WEDGWOOD CENTER DEVELOPMENT

Early Design Guidance - 2

SDCI # 3040032-EG

10/28/2024

EDG 1 - View looking Northeast from 35th and 82nd

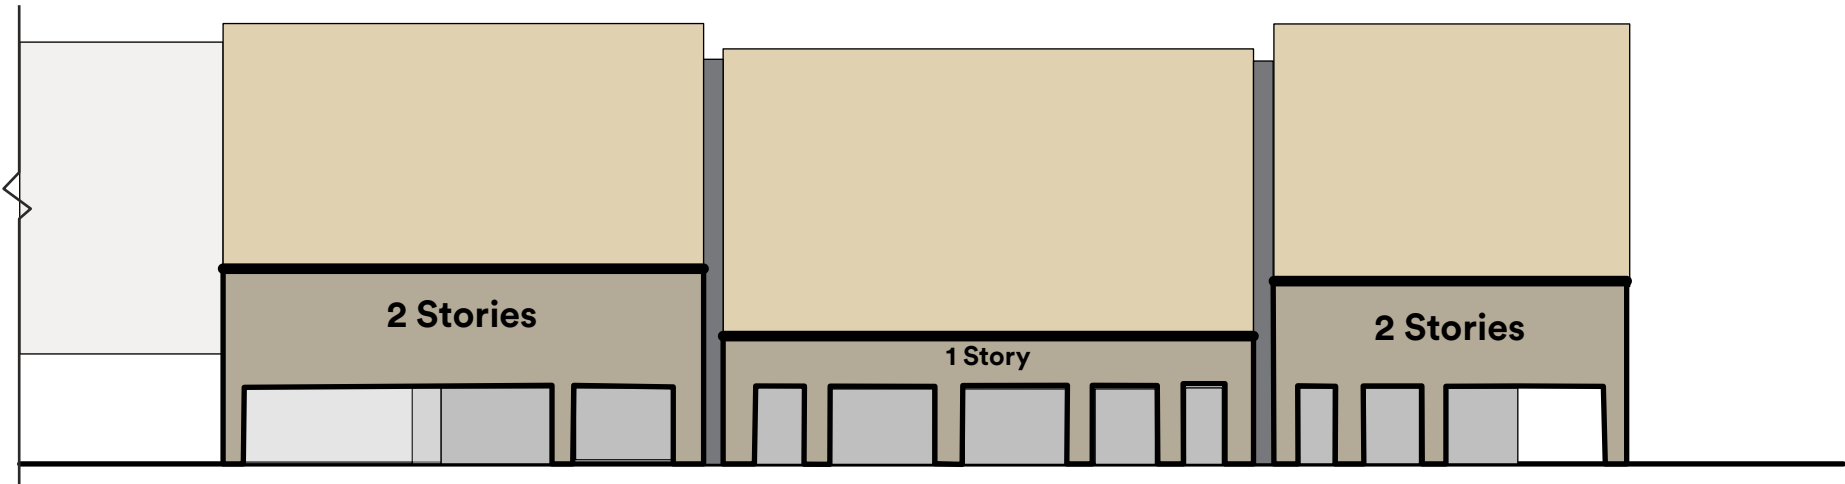
- A. **Request for** further studies on street level activation at sidewalks on retail edges
- B. **Request for** further detail on the pedestrian zone (first 15 feet) of the building

The Board discussed the development of the 35th Ave NE commercial frontage, noting the layout needed further definition to show how the commercial frontage will be developed to encourage activation. The Board requested that the applicant provide studies of the sidewalk spaces along the retail edges to create more opportunities for spill out and interior/exterior connection, noting the spaces should be scaled to the neighborhood and uses. They commented that light and air at sidewalk level should be maximized by creating spaces that are open to the sky.

EDG 2 - View looking Northeast from 35th and 82nd

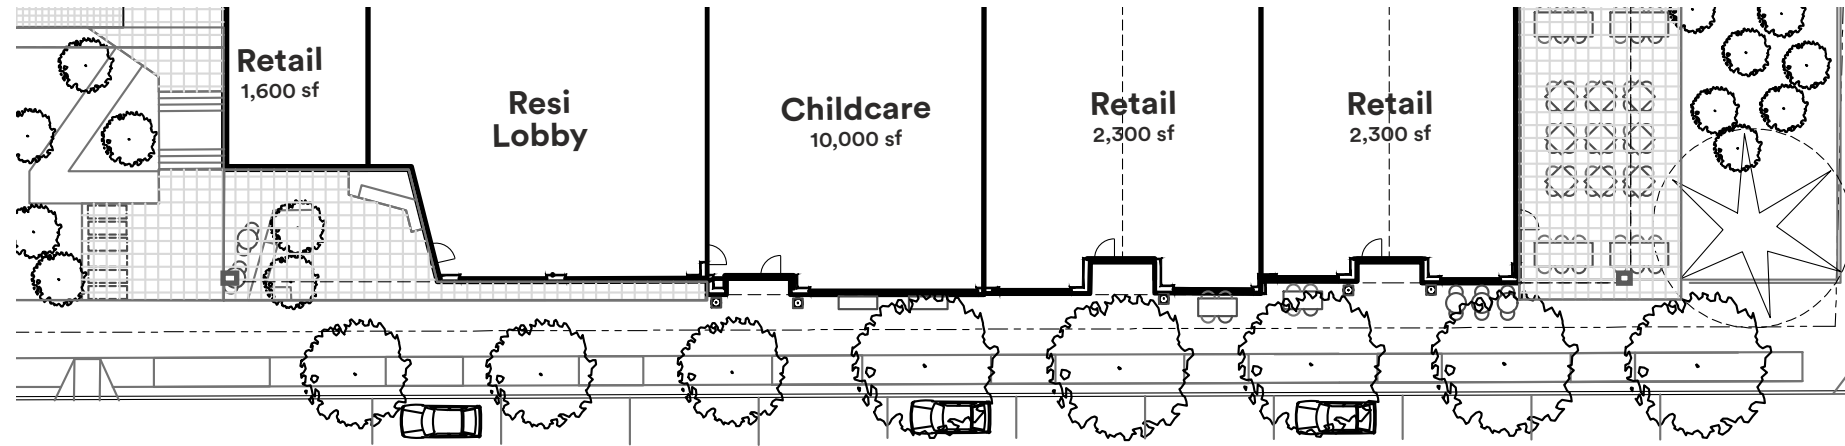
- A. **Request for** further studies on street level activation at sidewalks on retail edges
- B. **Request for** further detail on the pedestrian zone (first 15 feet) of the building
